Technical product information

Topic	Rear door blind fails to deploy – Outer frame finisher baulking
Market area	Worldwide Bentley (1WBE)
Brand	Bentley
Transaction No.	2035539/1
Level	EH
Status	Approval
Release date

Rear door blind fails to deploy – Outer frame finisher baulking

Figure 2

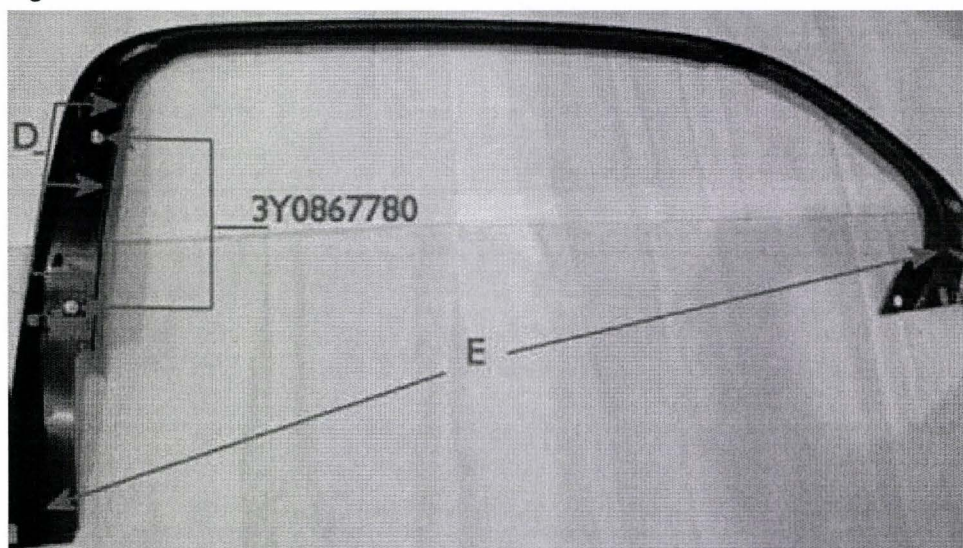
2. Remove inner frame finisher (see Figure 2). This finisher is retained by two clips (part number 3Y0867780) and three integral lip bars (D) that engage in the door frame. Adhesive tape may also be used at various positions (E) around its periphery (see Figure 2a). Dexterous use of trim tool and spatula at the securing points shown in figure 2a will release this trim part

Figure 3

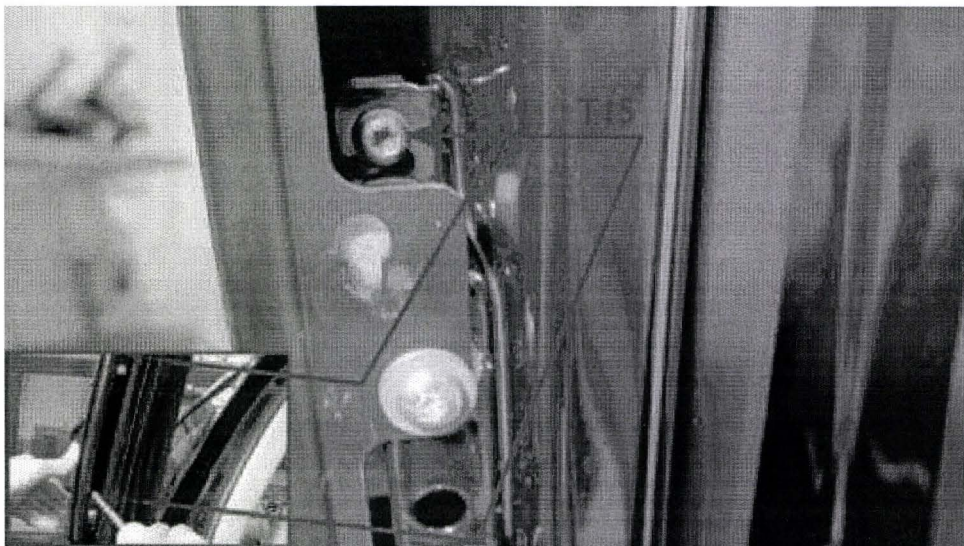
3. Remove the two T15 fasteners securing the outer frame finisher, remove and discard the outer frame finisher (see Figure 3)

Figure 4

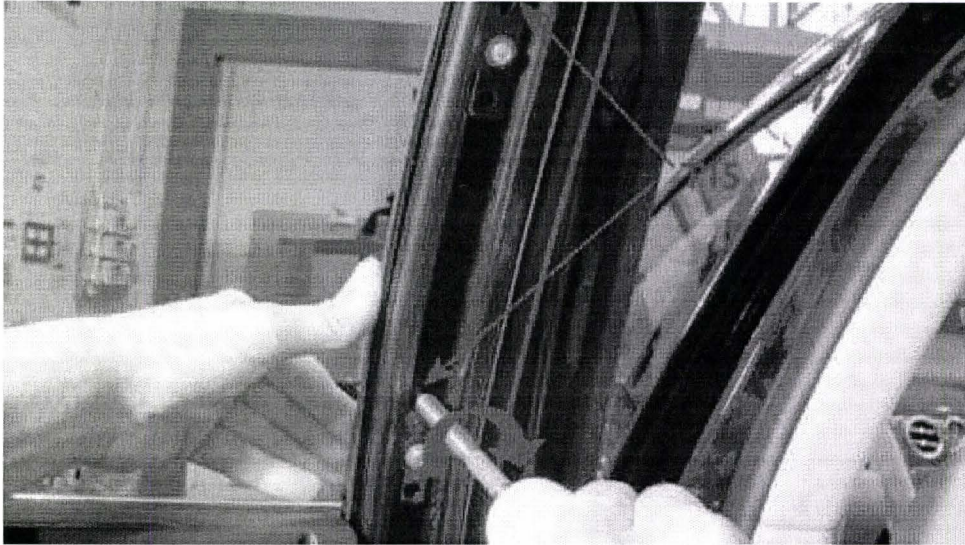
4. Position the new outer frame finisher (part number 4W0854909B) (see Figure 4). When fitting the outer frame finisher ensure it engages in the shallow recess at the side of the flocked seal (see inset Figure 4)
